Addendum No. 2

Bear Creek Redwoods Public Access Project

Date: April 3, 2018

Sheet Number : C4.4

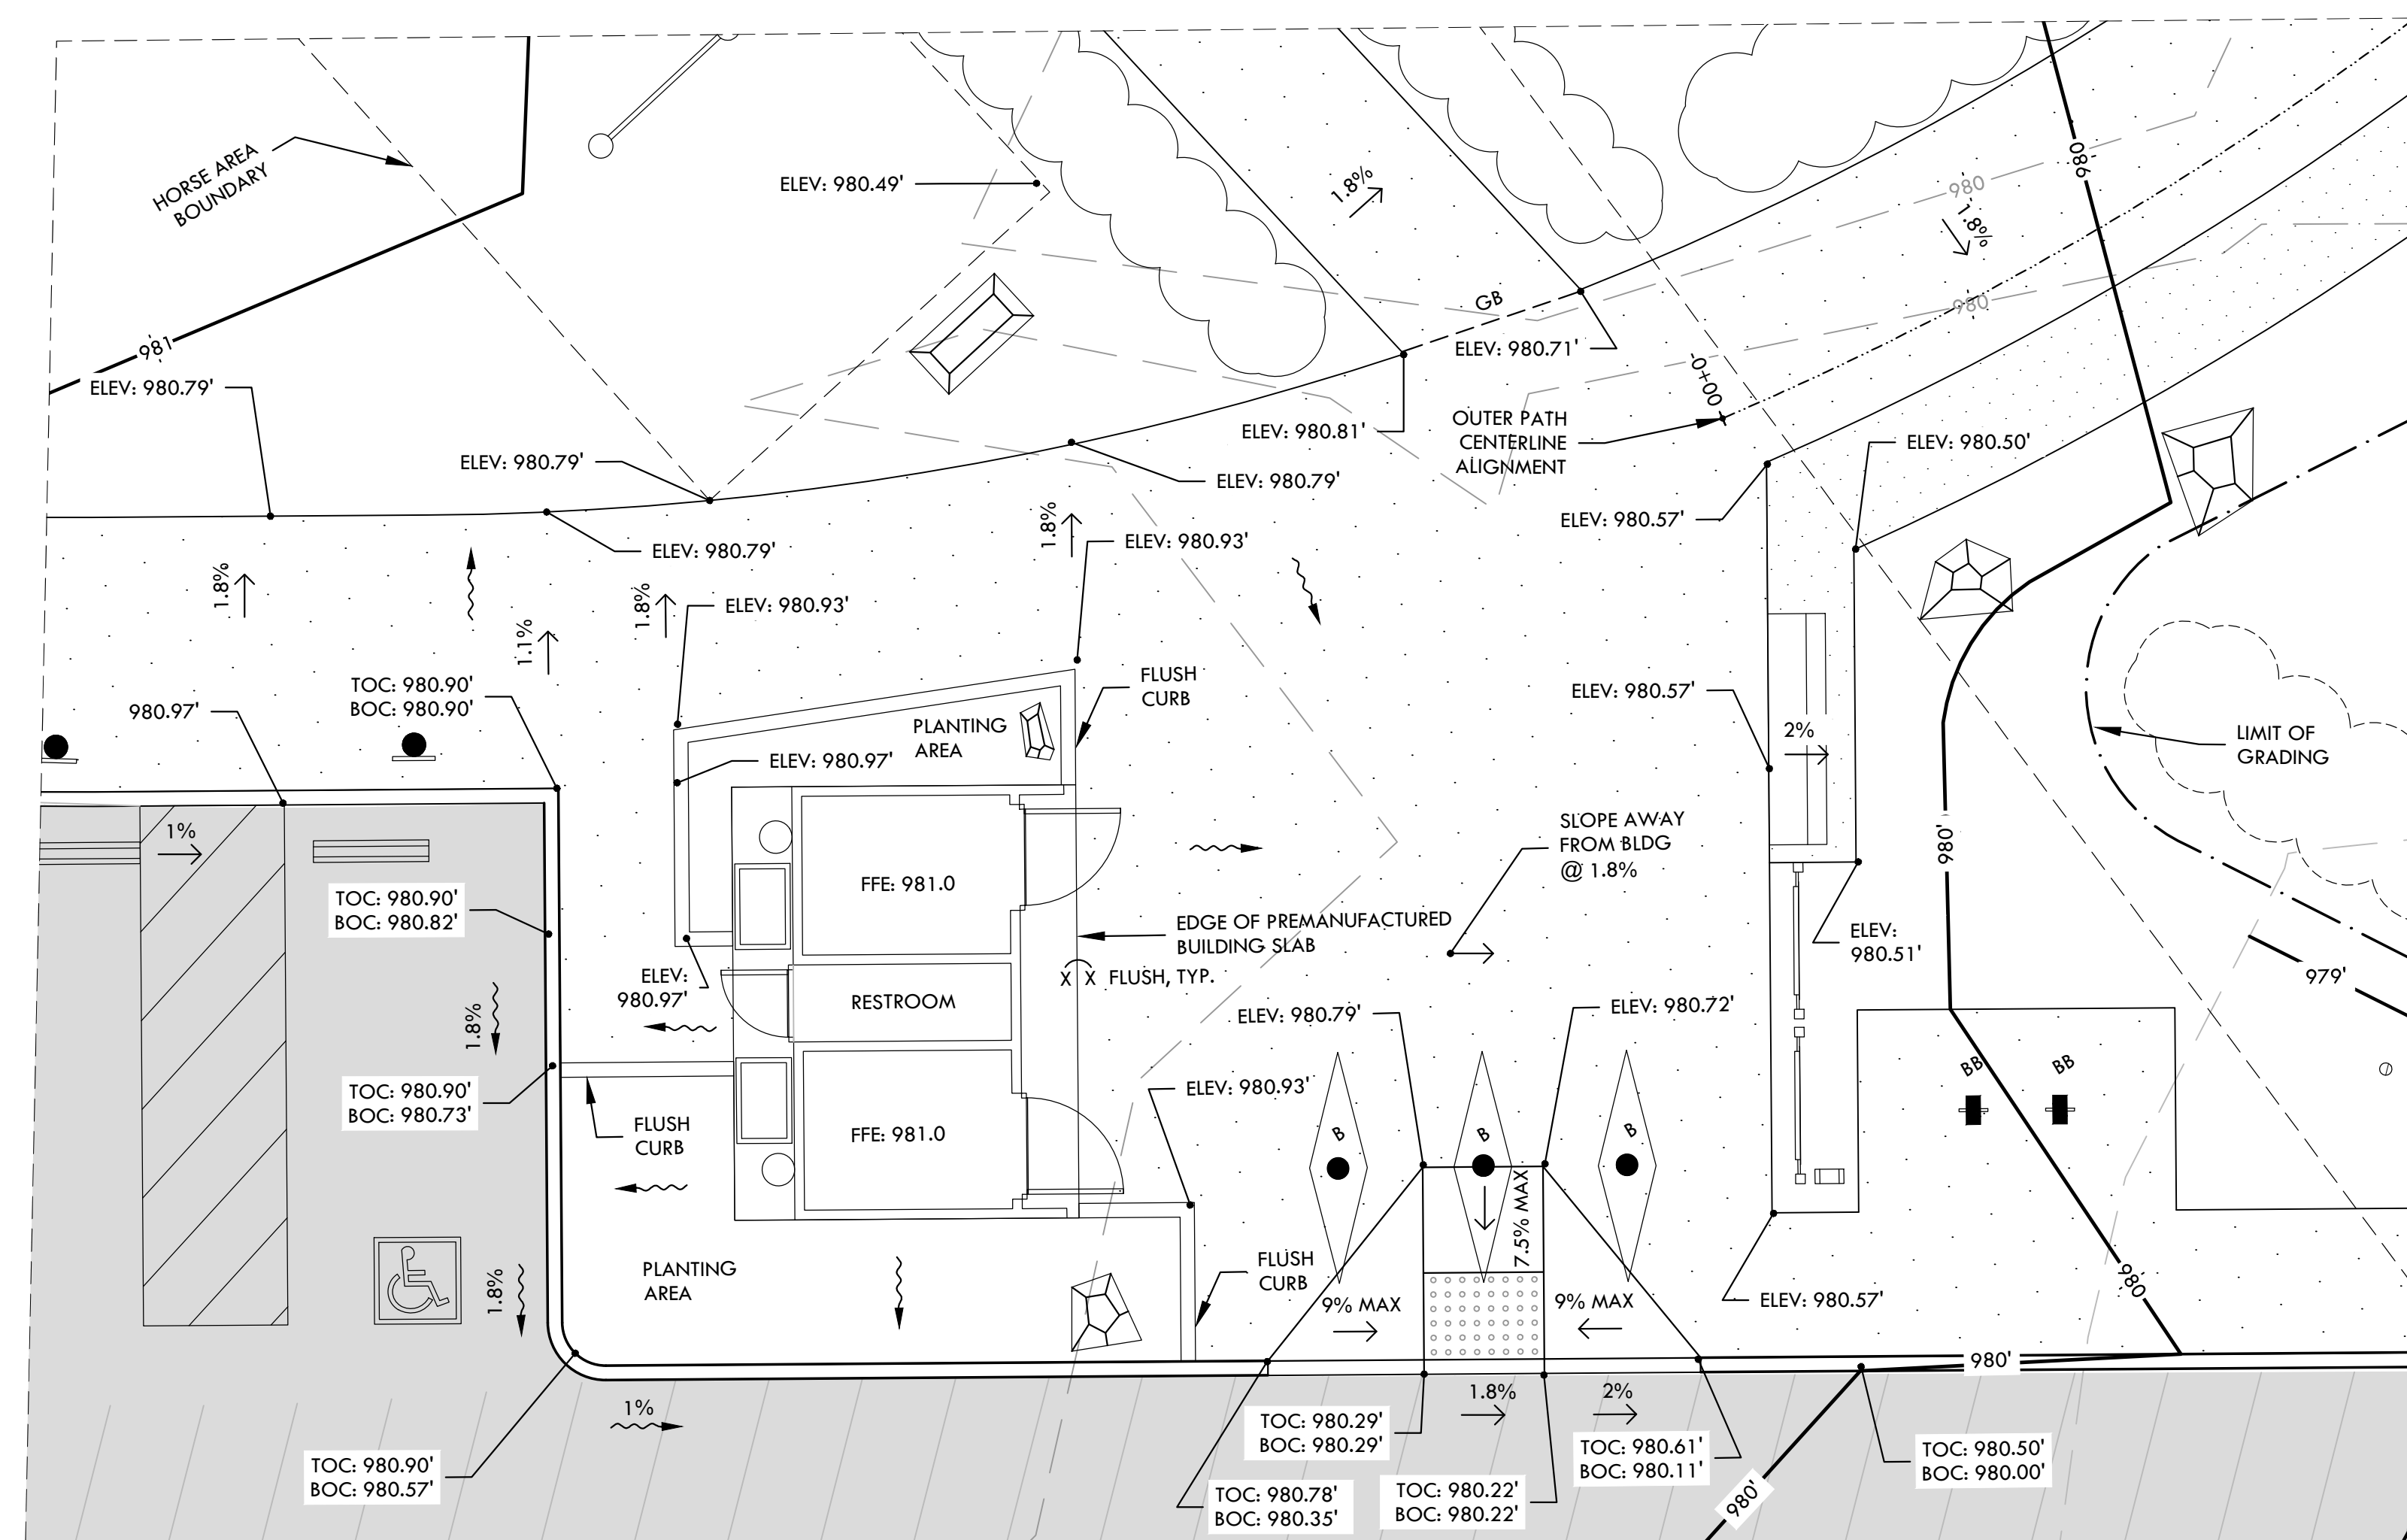
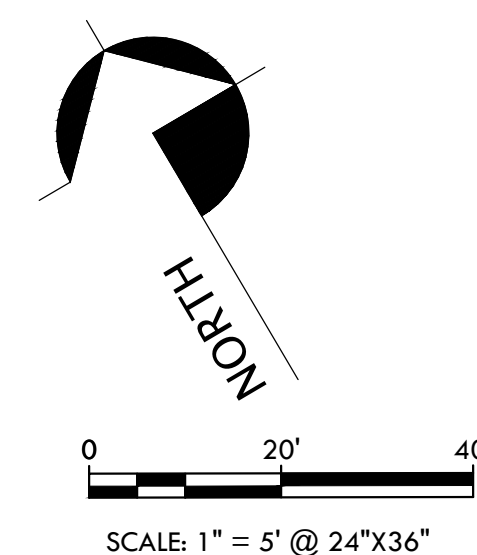
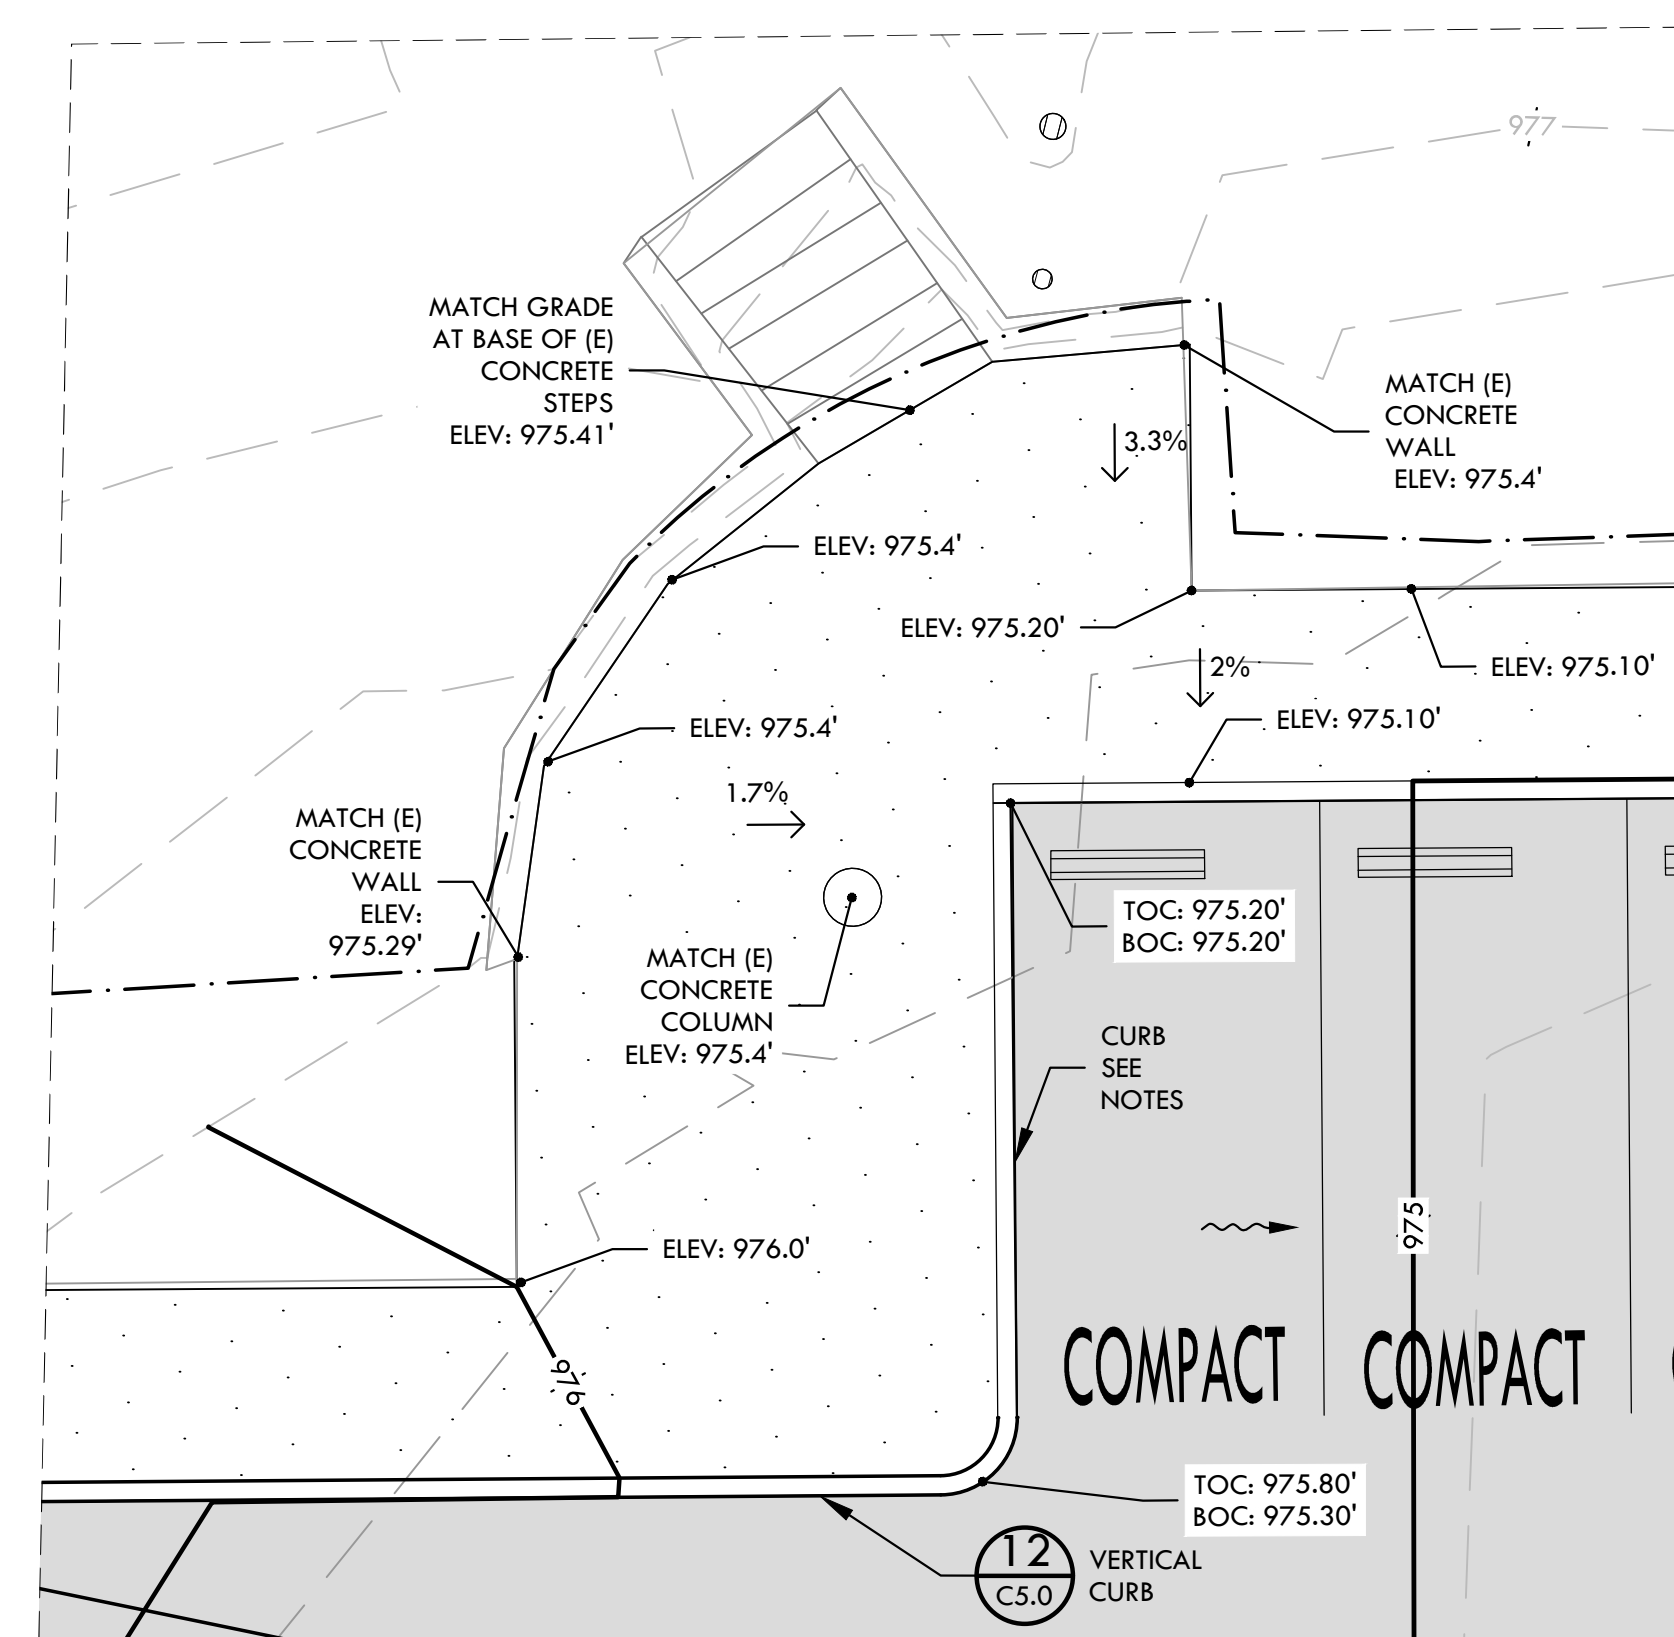
- a. Replace existing Sheets C3.0, C4.0-C4.4, C5.0, L2.2, L5.1, and L5.4 with attached revised sheets.
 - i. C3.0 – Changed striping and stall notes
 - ii. C4.0 – 4.4 – Changed grading near concrete stairs, added enlargement detail of stairs, added spot elevations throughout, added note regarding culvert location and protection in places, minor revisions to sections and profiles.
 - iii. C5.0 Revised pond overflow detail.
 - iv. L2.2 added truncated domes along north edge of parking lot
 - v. L5.1 revised Detail 4, truncated domes
 - vi. L5.4 revised Detail 1 and Detail 3 to add a 4th bollard and associated striping.

4 TRUNCATED DOME PER STANDARD PLAN A88A
SCALE: N.T.S.

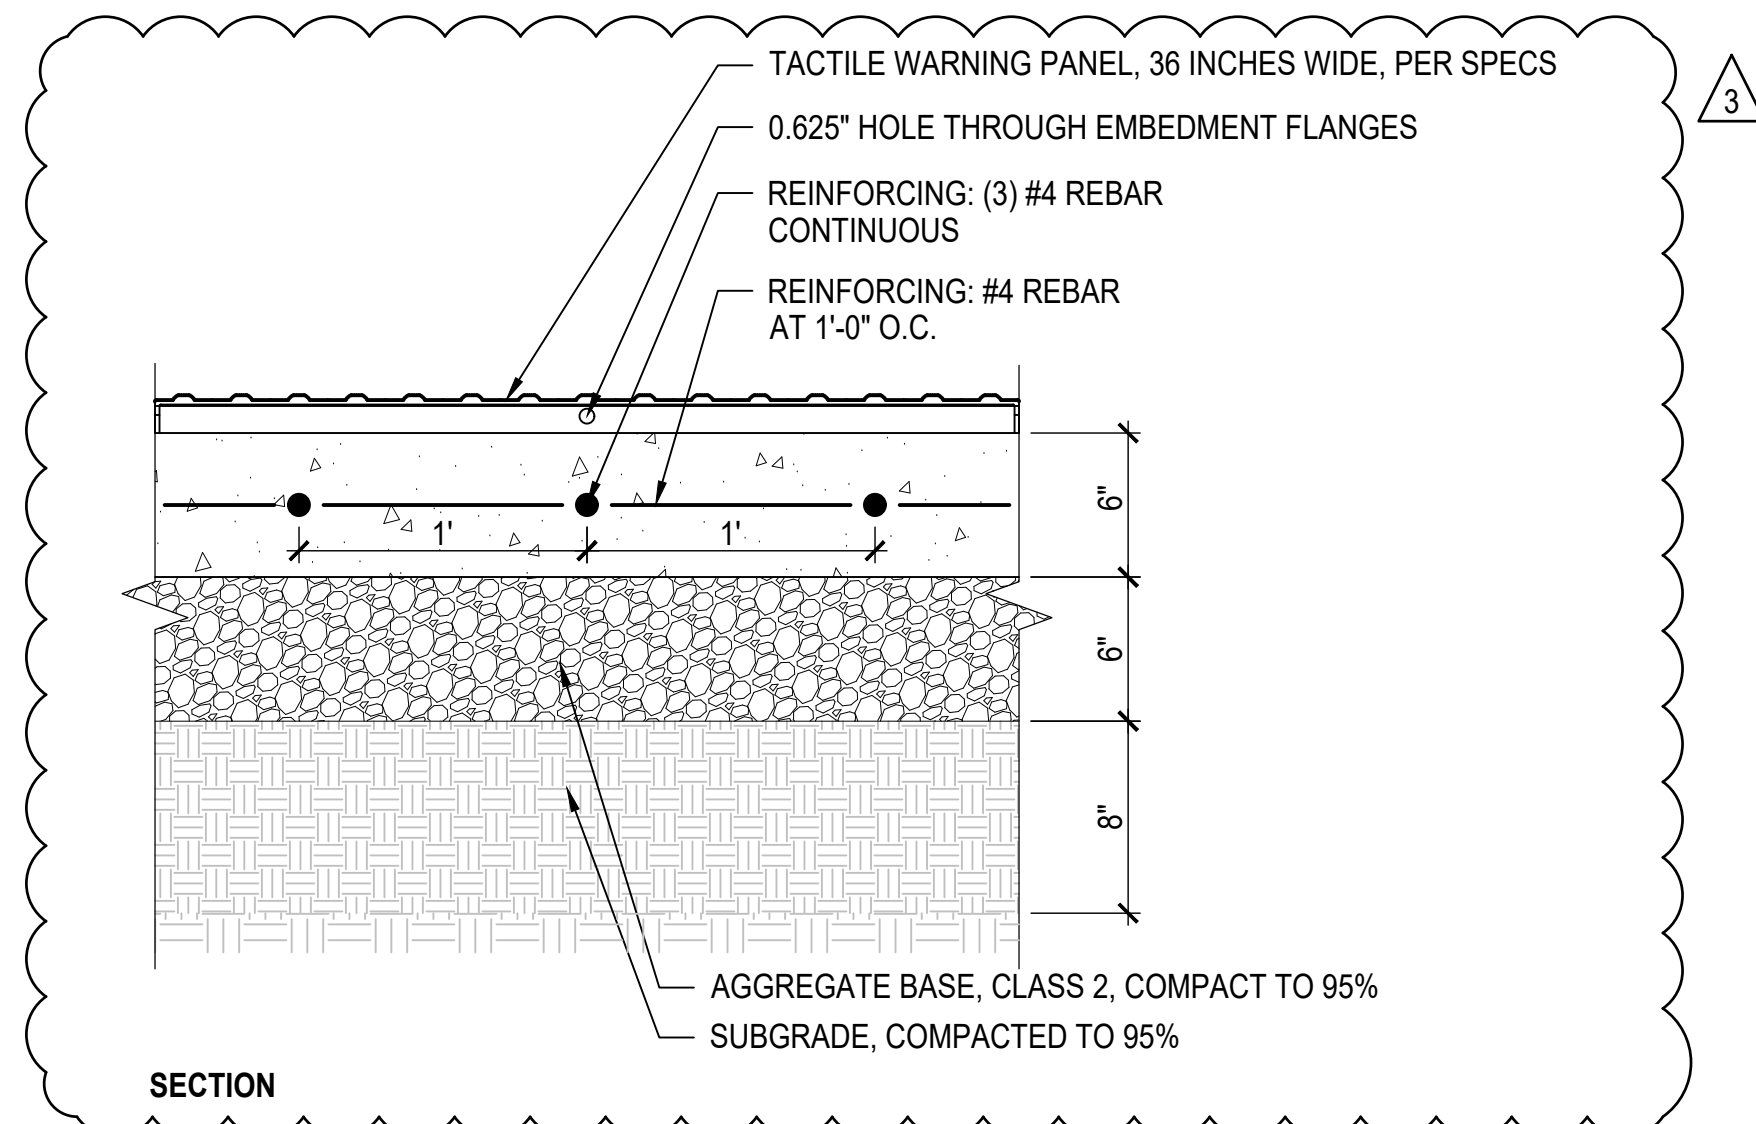
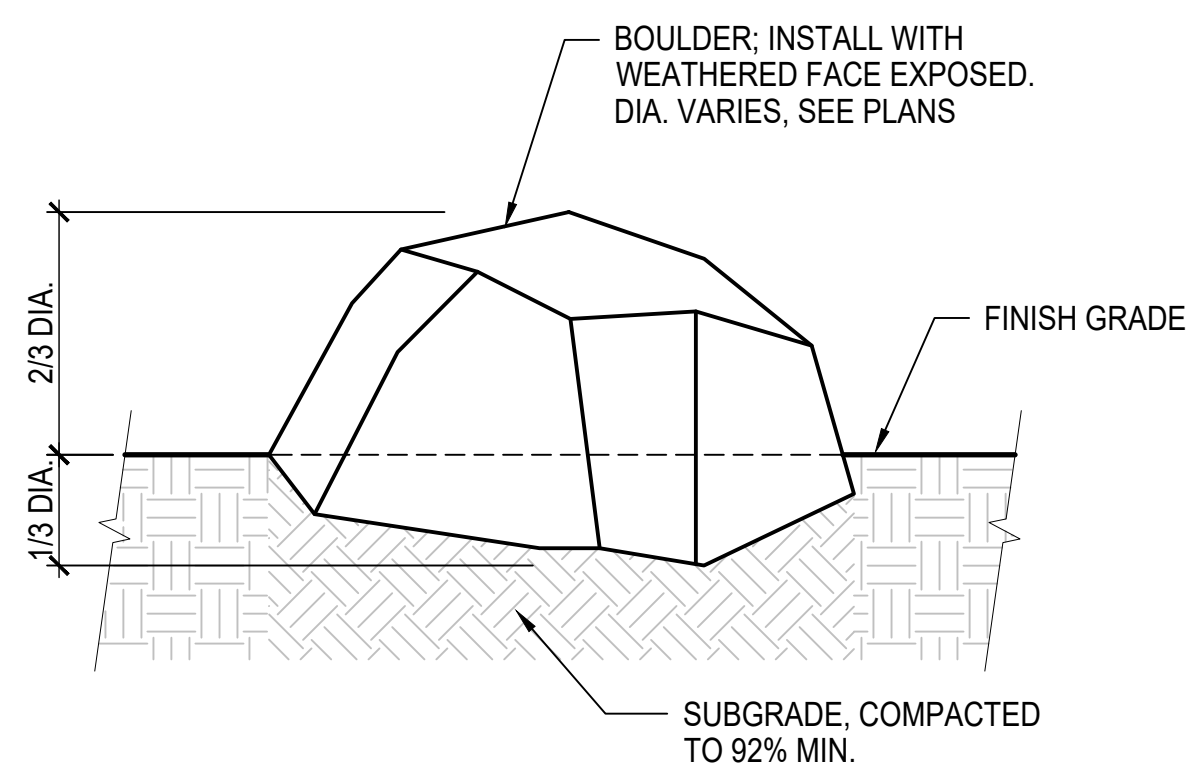
- 3) Q: What are the water plans for constructing the Webb Creek Bridge?**
A: No dewatering from pier drilling can be put into the creek.
- 4) Q: Are the truncated domes cast in place or surface mounted? Dimensions?**
A: Please see new attached Tech Spec Section 32 17 16 more info on truncated domes
Dimensions are provided on Sheet L5.1 Detail 4.
